Tusuka Apparels Ltd/Jeans & Polo Ltd

BSCIC Industrial Area, Tongi, Gazipur, Dhaka
(23° 53' 35.26"N, +90° 24' 56.68"E)

3 February 2014

Building Observations

Columns appear to be stressed in excess of normal design limits

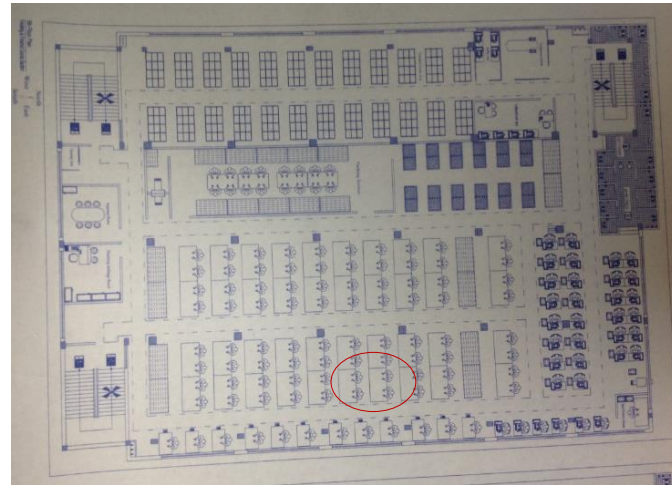
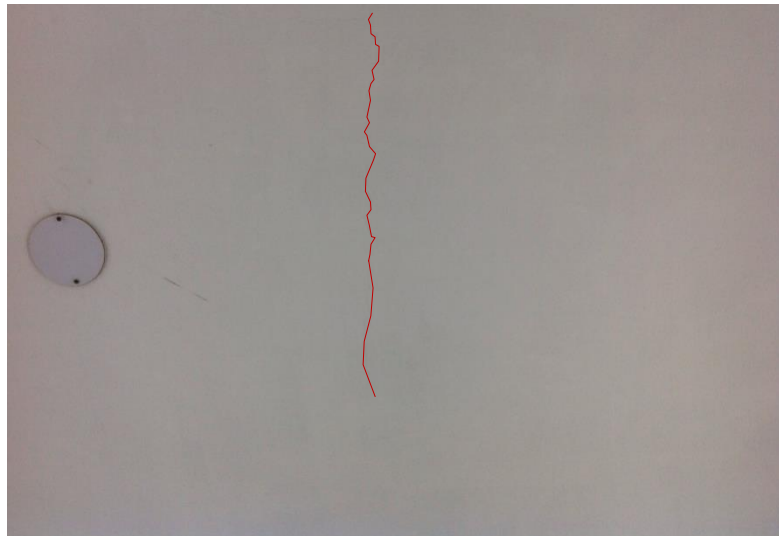
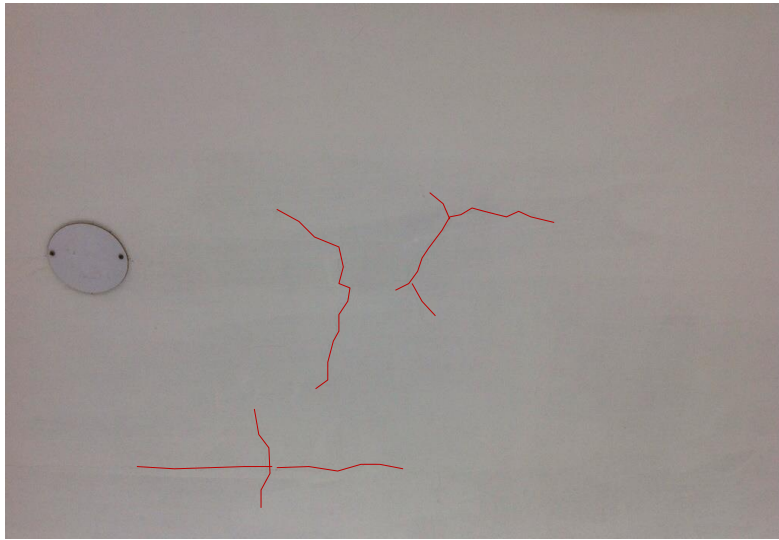
**Columns appear to be stressed in excess of
normal design limits**

Cursory calculations indicate that column size appears to be smaller than required by code for the applied dead and live load, assuming typical concrete strength

Brick aggregate seen when plaster removed.

Building Engineer to perform detailed calculations and concrete tests to prove column size and (if required) :

- Reduce loads by preparation of allowable floor loading plans
- Carry out strengthening works

Cracking to concrete beams and slab

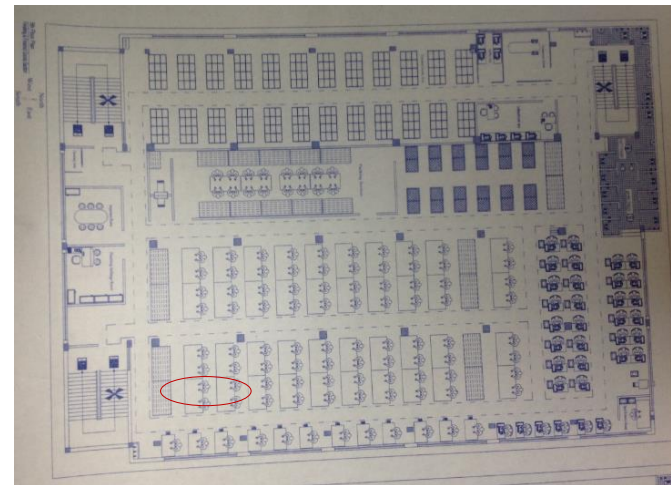
**Cracking to concrete beams on the underside
of 2nd, 4th and 5th floors**

Hairline crack in finishes to underside of beams close to the midspan is quite typical. This example is on the underside of the 2nd Floor. Similar examples seen on the underside of the 2nd, 4th & 5th Floor.

Cracking to concrete beams and slab

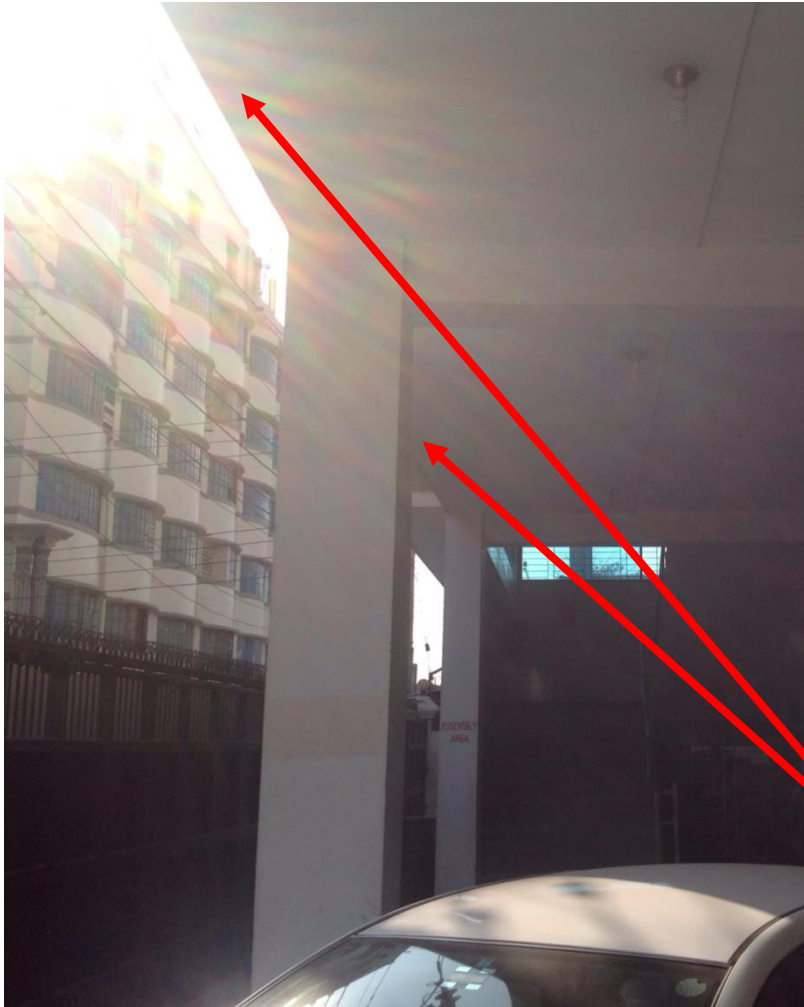
**Cracking to concrete slab on the underside of
the 5th floor**

**Underside of 5th floor slab (Seen from 4th floor)
Building Engineer to assess.**
